From: Eudy, Michael
Sent: Thursday, April 24, 2014 4:42 PM
To: Lu, Shanlai; Pohida, Marie; Budzynski, John; Le, Hien
Cc: Frankl, Istvan; McKenna, Eileen; Mrowca, Lynn; Phan, Hanh; Segala, John; Wunder, George; Miernicki, Michael; ArevaEPRDCDocsPEm Resource
Subject: FW: RAI 579 Response - Slides for 4/28 Public Meeting
Attachments: RAI 579 US EPR FSAR Markups for Discussion Only - 4-28-14-.pdf
Importance: High

U.S. EPR Design Certification

RAI 579 Response – US EPR FSAR Markups

April 28, 2014

Figure 5.4-19 Level Control During Midloop Operation

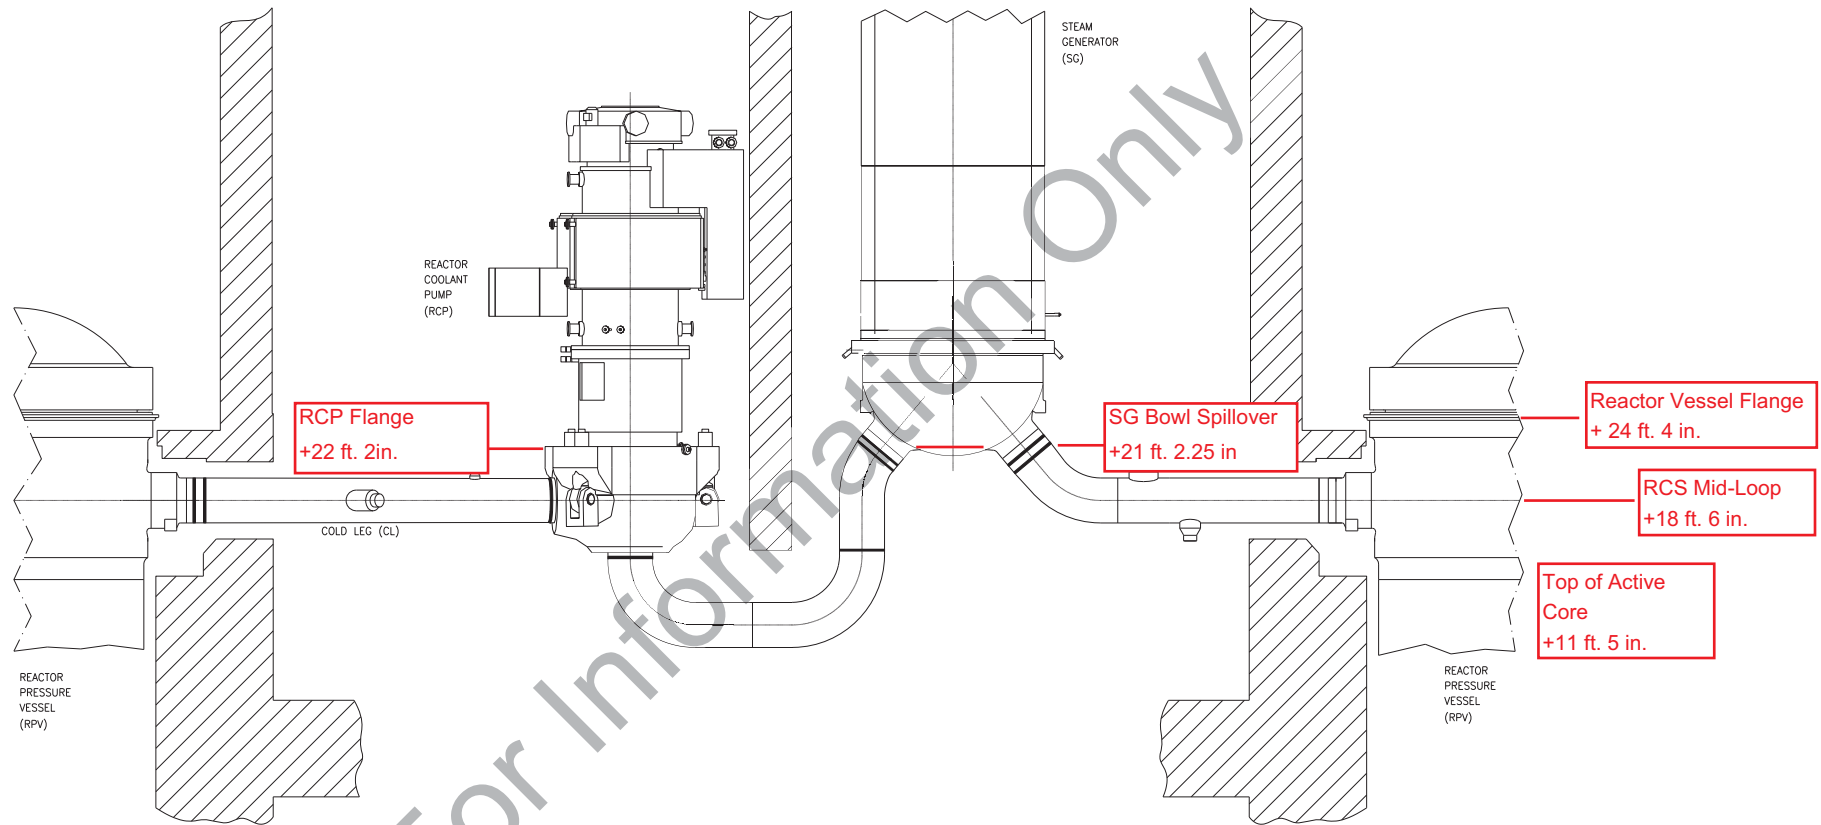
Loop Level	The RCS loop level control during mid-loop
Control Function	operation is regulated by the CVCS high pressure charging pumps and CVCS low pressure reducing station. <u>See Section 7.7.2.2.3 for a description of loop level control.</u> After the loop level control mode has been manually validated, certain automatic protection functions are actuated. <u>The nominal control band is shown on Figure 5.4-19.</u>

This setpoint initiates an open command for the CVCS low pressure letdown control valve in order to prevent inadvertent filling of the steam generator bowls ~~(without nozzle-dams)~~. The Max1 setpoint is shown on Figure 5.4-19.

This setpoint initiates full closure of the CVCS low pressure letdown control valve and the RHR and CVCS isolation valves in order to protect the LHSI pumps that are operating in RHR mode. This function covers the entire temperature range of the RHR system operation. The Min1 setpoint is shown on Figure 5.4-19.

This setpoint also initiates automatic stop of the LHSI pumps in RHR mode to prevent cavitation of operating LHSI pumps due to air ingestion. The Min1p setpoint is shown on Figure 5.4-19.

Table 7.1-5—SAS Automatic Safety Function

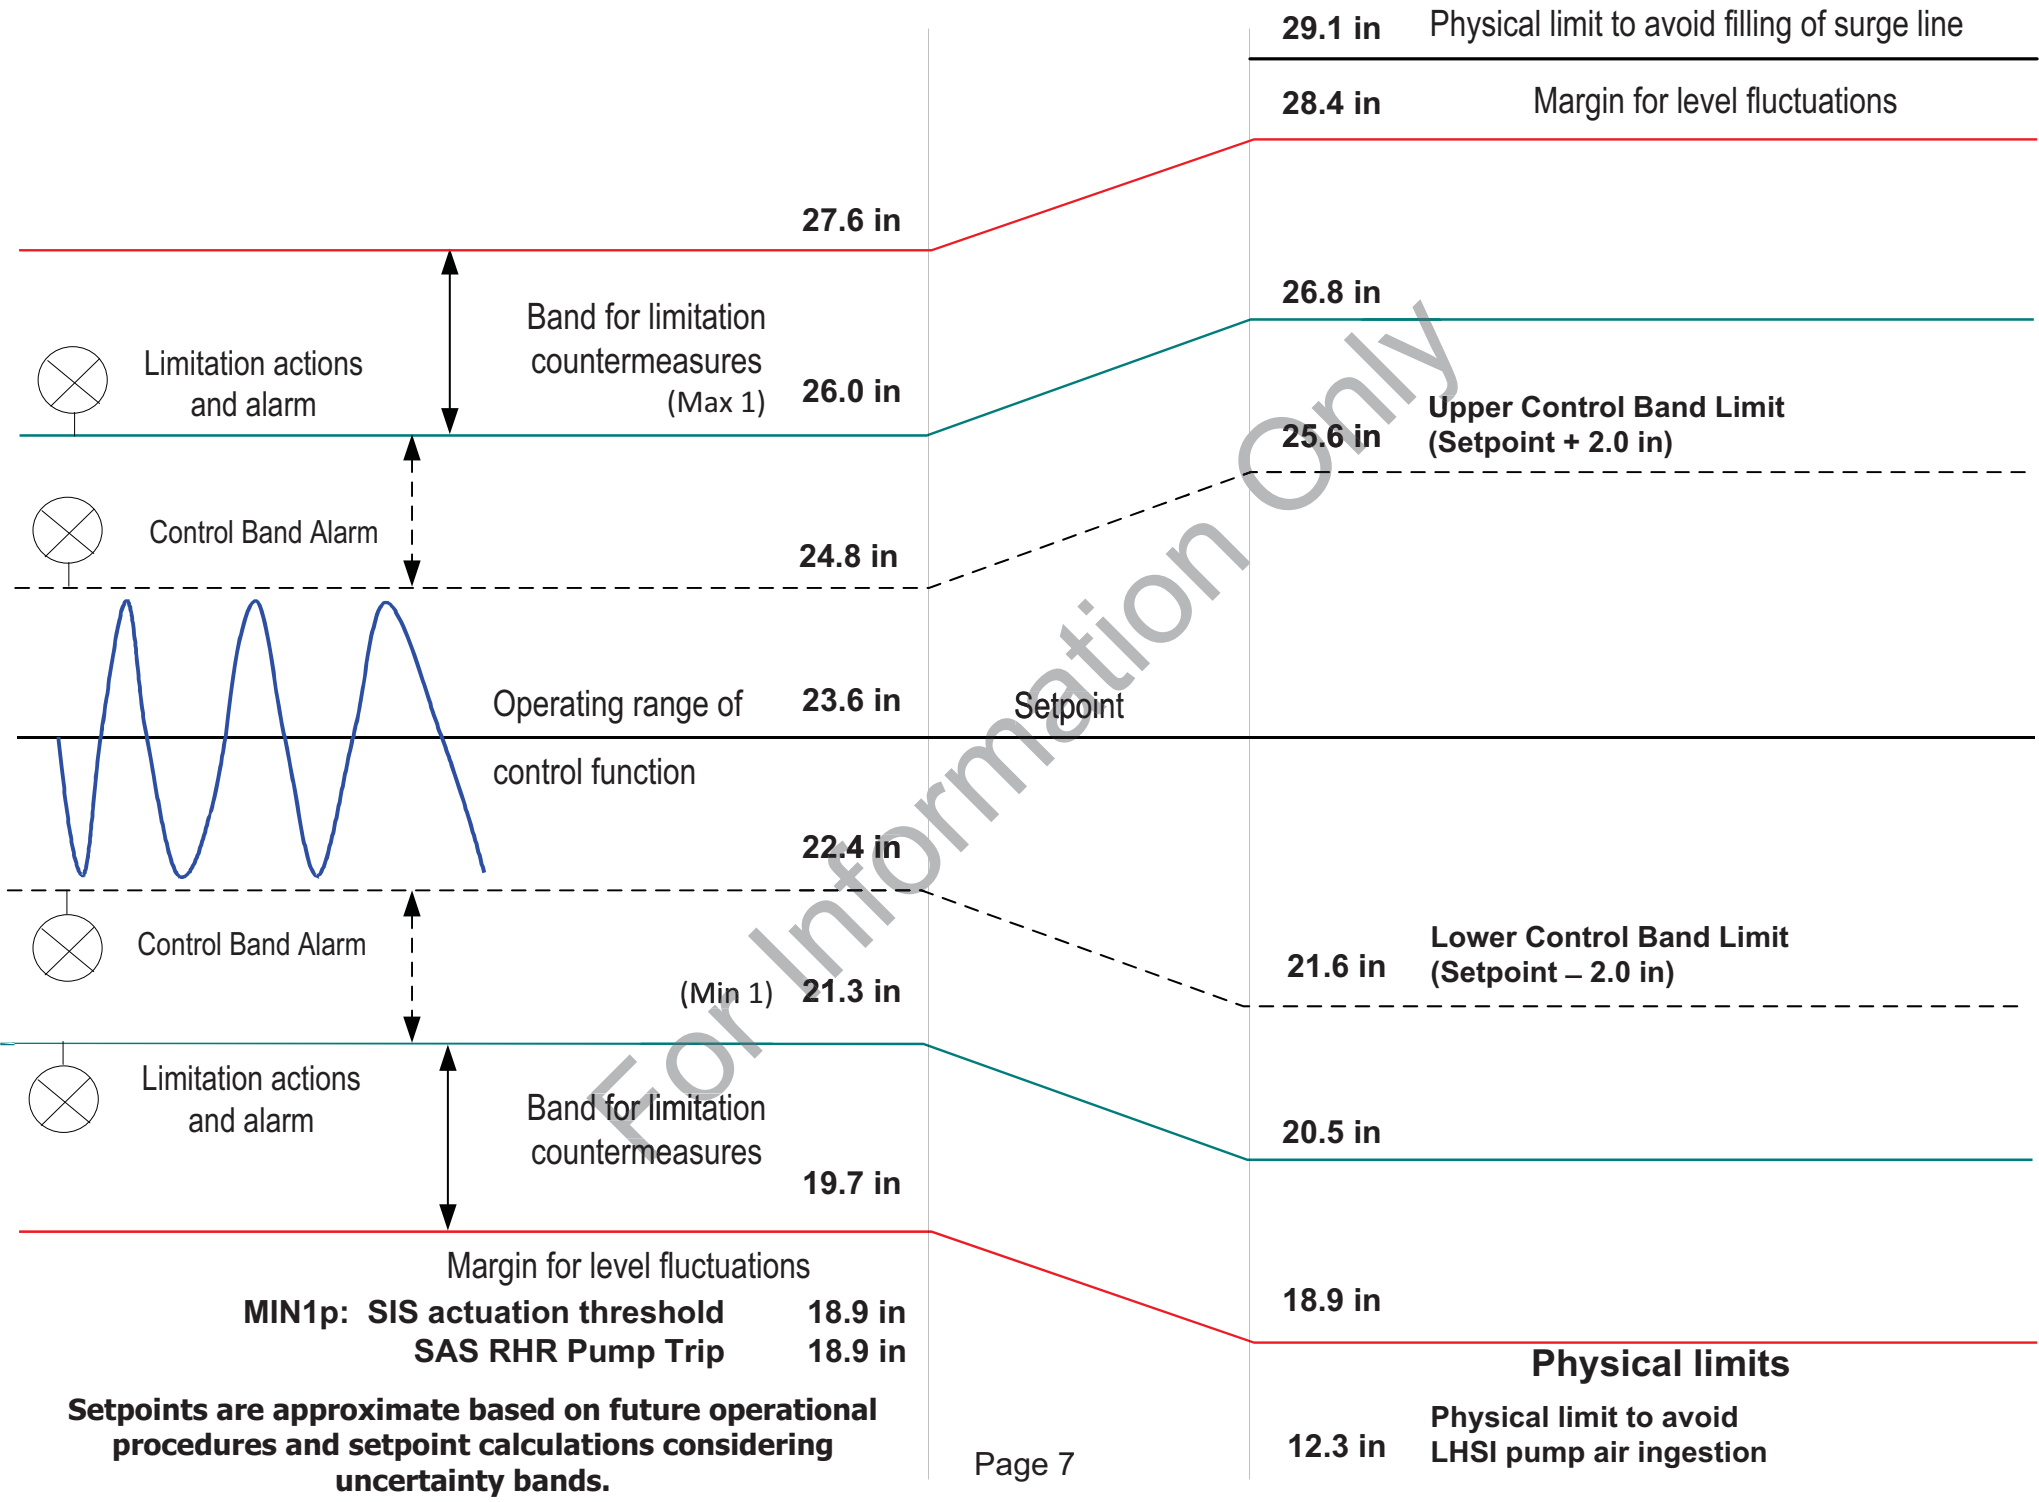
System ¹	Function Name ²	Function Safety Basis ³	Interdivisional Communications ⁴	Type of Data ⁵	Signal Selection Type ⁶	Function Initiation ⁷
<u>Safety Injection and Residual Heat Removal System (SIS/RHRS)</u>	<u>Automatic Trip of LHSI Pump (in RHR Mode) on Low ΔPsat Interlock (Figure 7.6-9)</u>	<u>This function is described in Sections 5.4.7, 6.3, and 7.6.1.2.2.</u>	<u>Interdivisional communications is required because a low ΔPsat discrete signal is generated in each division, and 2/4 voting logic is used to trip the LHSI pump. Valve position measurements from multiple divisions are used to determine if an RHR train is connected.</u>	<u>Discrete</u>	<u>Vote</u>	
<u>Safety Injection and Residual Heat Removal System (SIS/RHRS)</u>	<u>Automatic Trip of LHSI Pump (in RHR Mode) on Low-Low RCS Loop Level Interlock (Figure 7.6-10)</u>	<u>This function is described in Sections 5.4.7, 6.3, and 7.6.1.2.3.</u>	<u>Interdivisional communications is required because a low-low RCS loop level discrete signal is generated in each division, and 2/4 voting logic is used to trip the LHSI pump. Valve position measurements from multiple divisions are used to determine if an RHR train is connected.</u>	<u>Discrete</u>	<u>Vote</u>

Figure 7.6-9 - SIS / RHRs Automatic Trip of LHSI Pump (in RHR Mode) on Low ΔP_{sat} Interlock

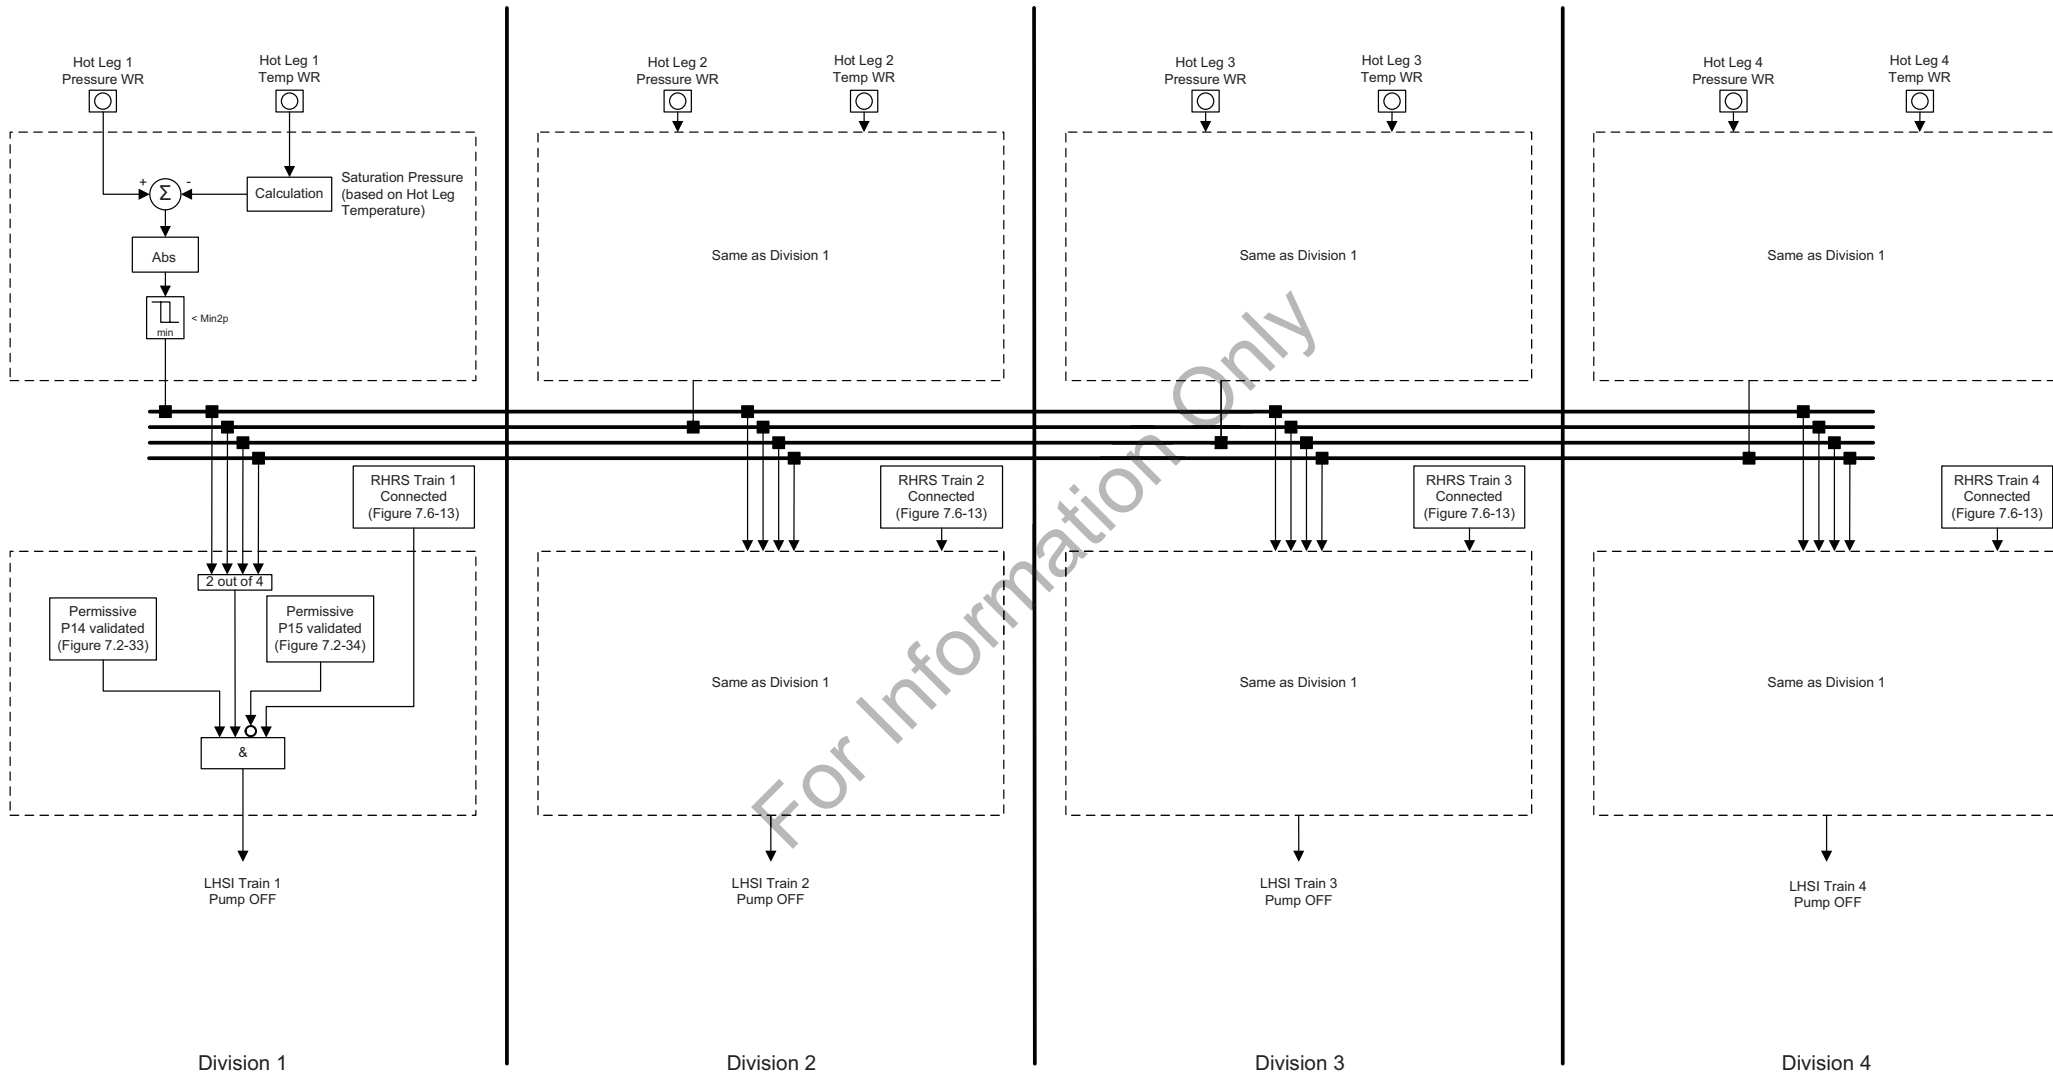
7.6.1.2.2 SIS / RHRS Automatic Trip of LHSI Pump (in RHR Mode) on Low Δ Psat Interlock

The SIS/RHRS has a safety-related function to provide the RCS residual heat removal to reach cold shutdown, refueling modes and to control primary temperature. The function to automatically trip the LHSI pump upon a low Δ Psat signal supports the safety-related function of providing residual heat removal by maintaining LHSI pump operability by shutting down the pump to prevent pump damage due to inadequate net positive suction head (NPSH) or unavailability due to stream binding following a failure that results in RCS conditions approaching saturation. The functional logic is shown in Figure 7-6-9 - SIS/RHRS Automatic Trip of LHSI Pump (in RHR Mode) on Low Δ Psat Interlock.

Figure 7.6-10 - SIS / RHRS Automatic Trip of LHSI Pump (in RHR Mode) on Low RCS Loop Level Interlock

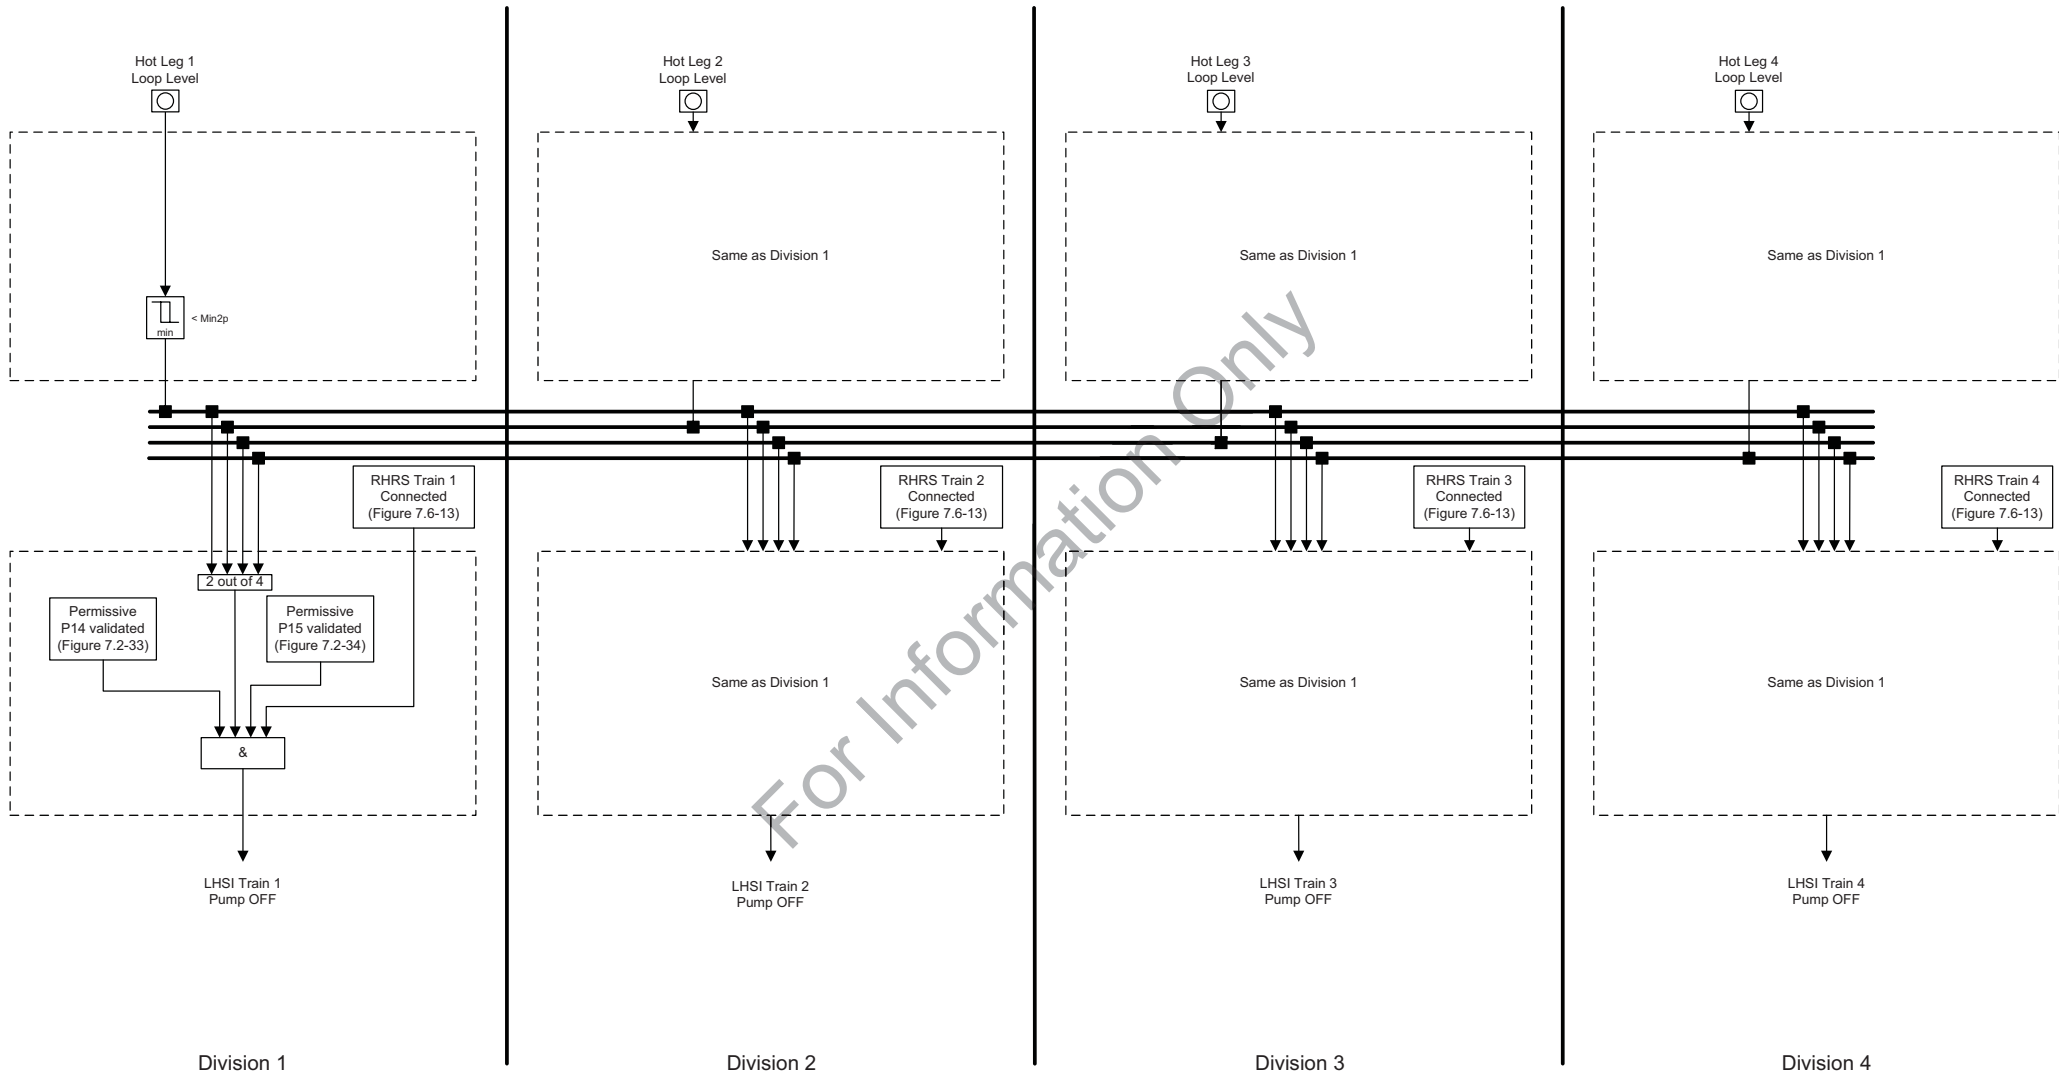
7.6.1.2.3 SIS / RHRS Automatic Trip of LHSI Pump (in RHR Mode) on Low RCS Loop Level Interlock

The SIS/RHRS has a safety-related function to provide the RCS residual heat removal to reach cold shutdown, refueling modes and to control primary temperature. The function to automatically trip the LHSI pump upon a low RCS loop level signal supports the safety-related function of providing residual heat removal by maintaining LHSI pump operability by shutting down the pump to prevent pump damage or unavailability due to air binding following a failure that results in low RCS loop level. The functional logic is shown in [Figure 7.6-10 - SIS/RHRS Automatic Trip of LHSI Pump \(in RHR Mode\) on Low RCS Loop Level Interlock](#).
